MEMORANDUM

SUBJECT: Staff Analysis for Permit Modification: Replacement Land Application Site Area for Class C Wastewater to the YMCA Horsethief Camp Wastewater Reuse Permit No. LA-000224-01

Re: Wastewater Reuse Permit, YMCA Horsethief Camp Wastewater Reuse System
Technical Report

Figure 2A
Vicinity Map

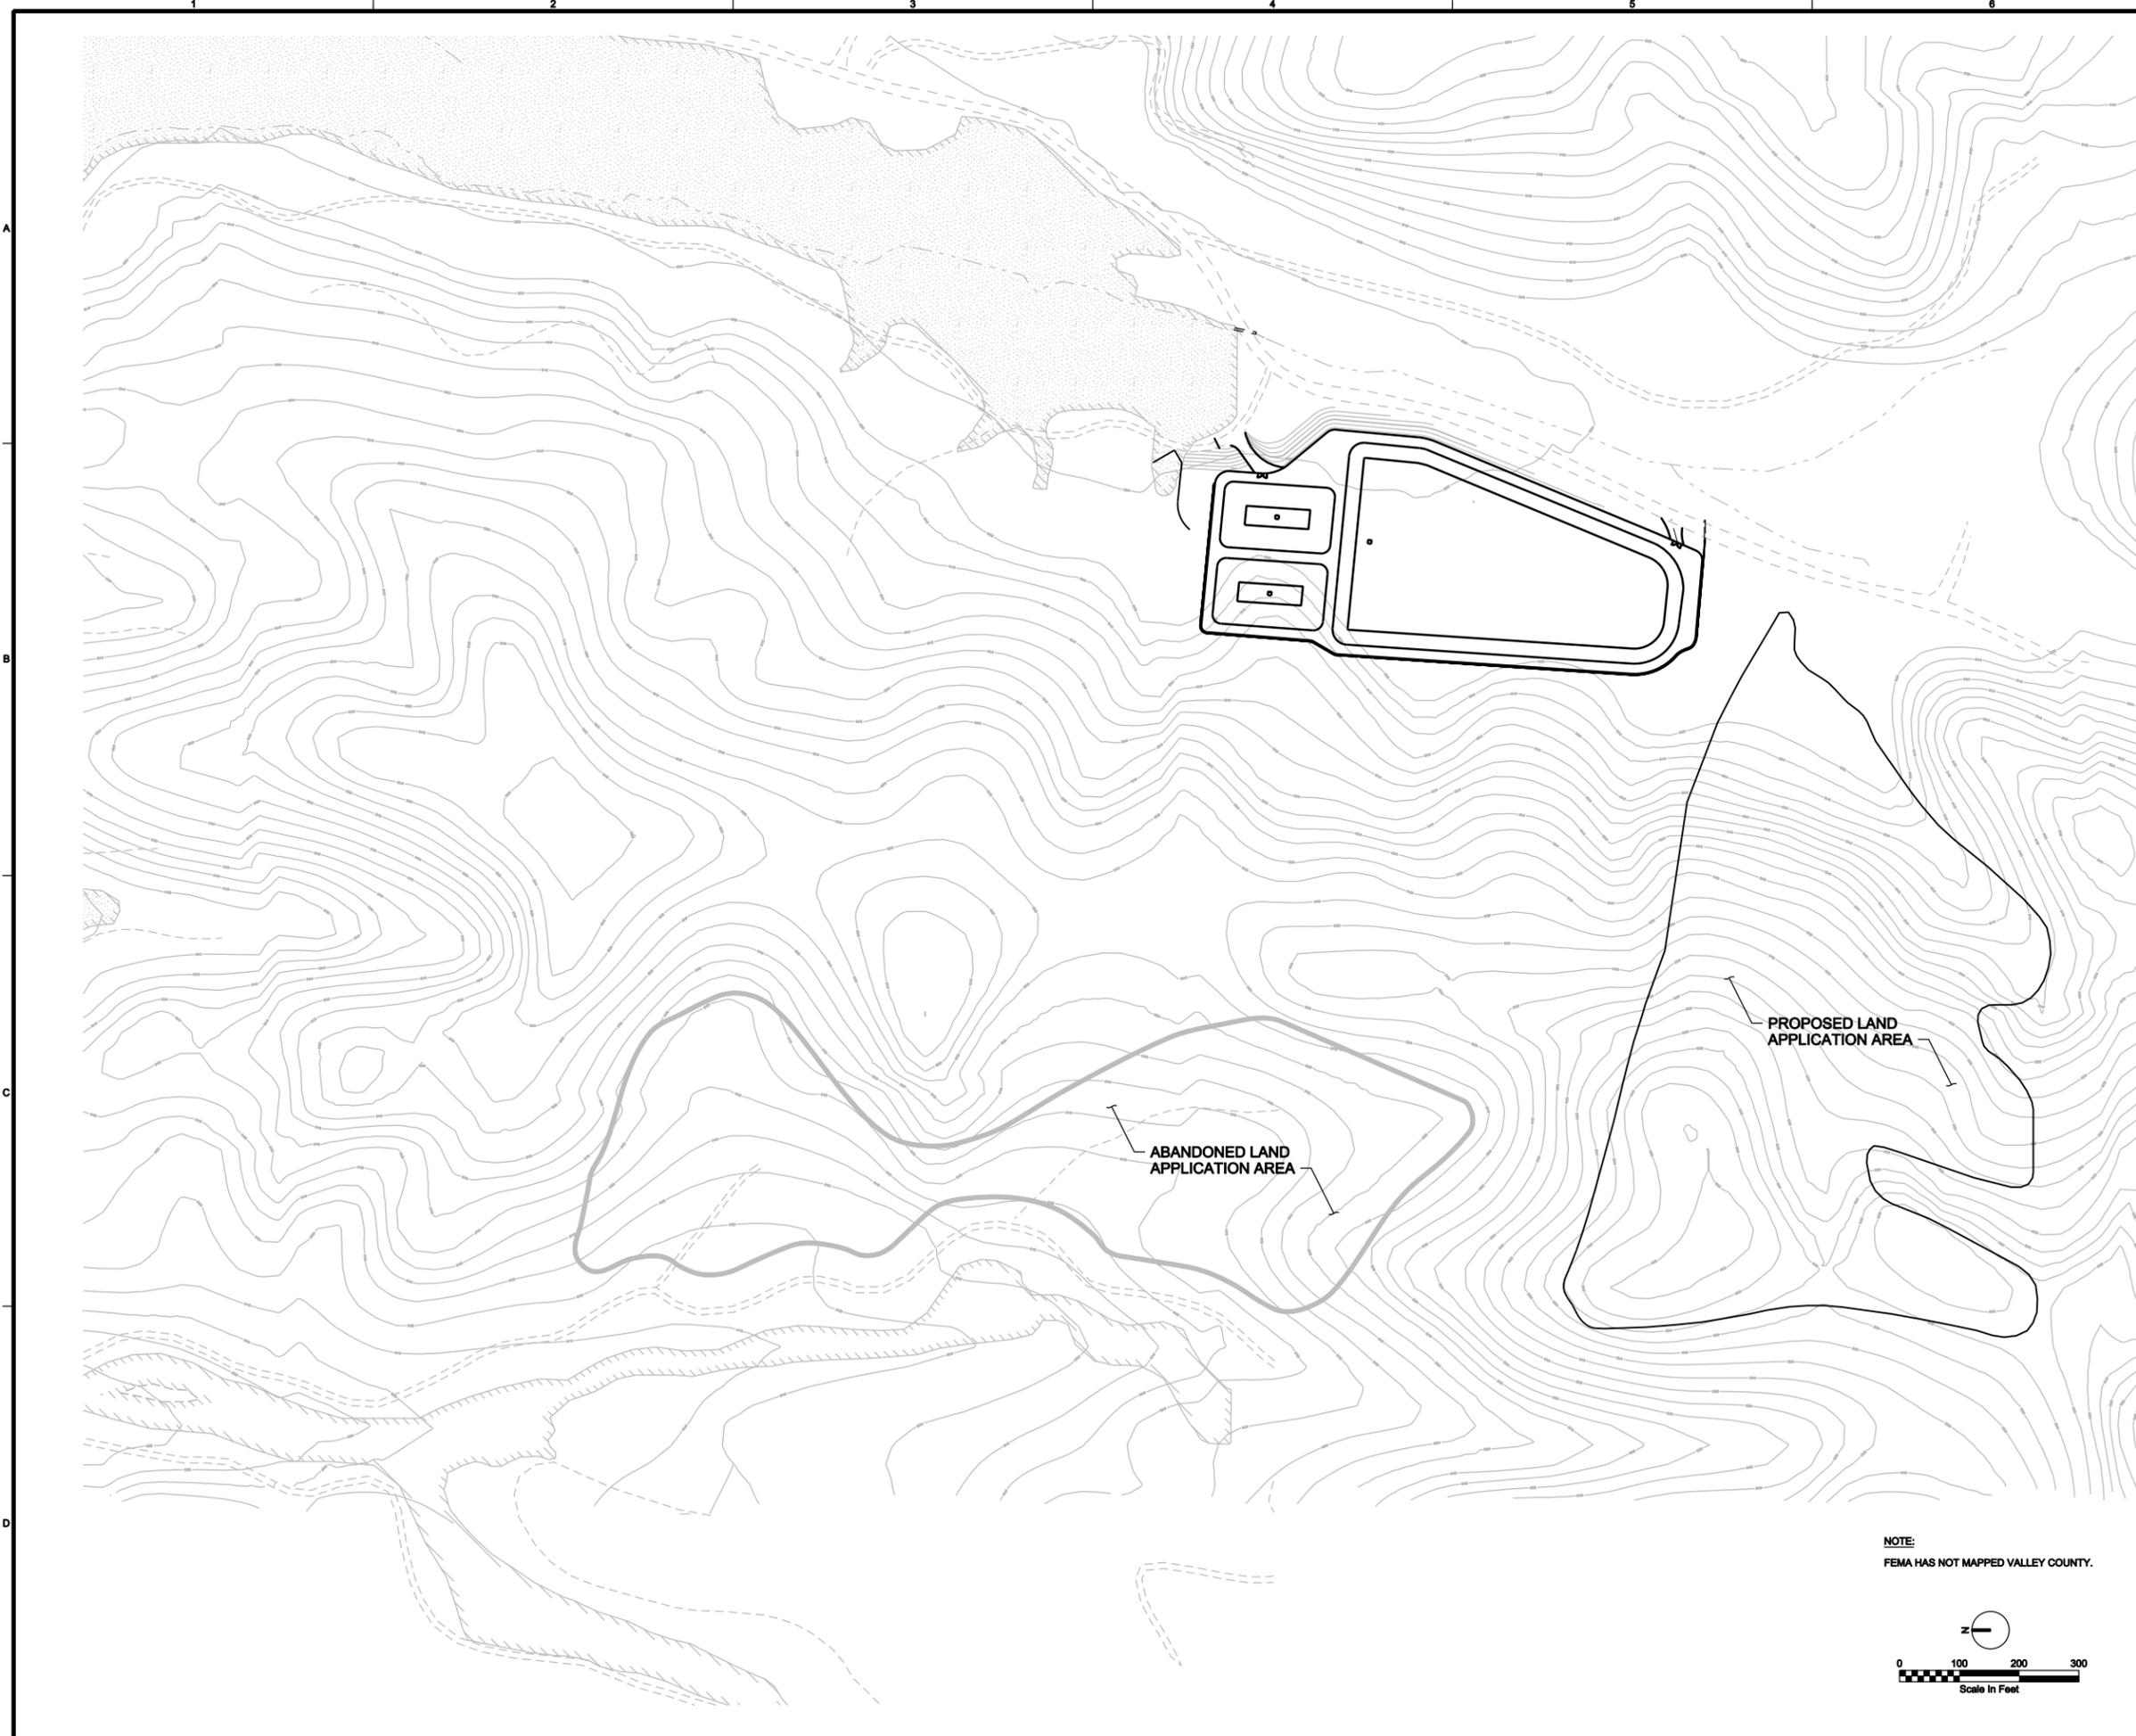
The submitted technical report describes the proposed replacement and discusses the advantages of the proposed land application site area over the existing permitted land application site area. The proposed land application site area is 14.4 acres, which is 6.4 acres larger than the existing permitted 8 acre land application site area, and is located within the existing property boundaries of the YMCA Camp. The advantages of the proposed land application site area are as follows:

- The proposed land application site area is adjacent to the WWTF and will minimize pumping costs.
- The proposed land application site area has a greater separation from the wetland areas (600 ft. vs. 100 ft.)
- The proposed land application site area is larger and will provide more operational flexibility.
